REQUEST

Current Zoning: R-3 (single family residential)
Proposed Zoning: R-8(CD) (single family residential, conditional)

Approximately 4.98 acres located on the south side of Sam Neely Road, west of Steele Creek Road, and east of Krislyn Woods Place.

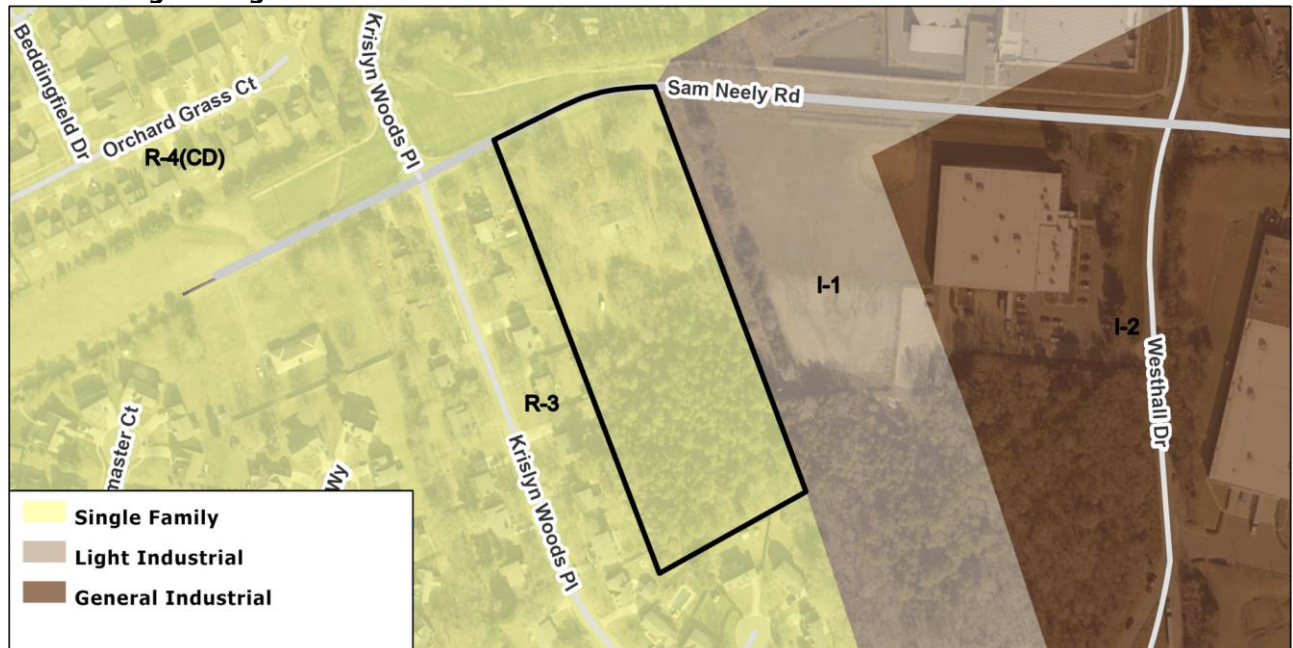
1. ~~Adjust buffers for the site's eastern boundary to reflect a 35' Class A Buffer which can only be reduced by 25% with a berm.~~ Addressed

2. ~~Adjust tree save areas shown on the site plan to ensure compliance with the Tree Ordinance.~~ Addressed

3. ~~Adjust total number of committed parking spaces from 53 to 54 to accurately reflect the commitments of 2 spaces per unit and 6 visitor spaces.~~ Addressed

4. ~~Add open space details in note I, which are committed to on the site plan and in the Development Data Table.~~ Addressed

5. ~~Show and label the visitor spaces on the site plan.~~ Addressed
6. ~~Update conditional notes to reflect the width of the planting strip to what is shown on the site plan.~~ Addressed
7. ~~Update conditional notes to reflect the width details of both buffers to what is shown on the site plan.~~ Addressed
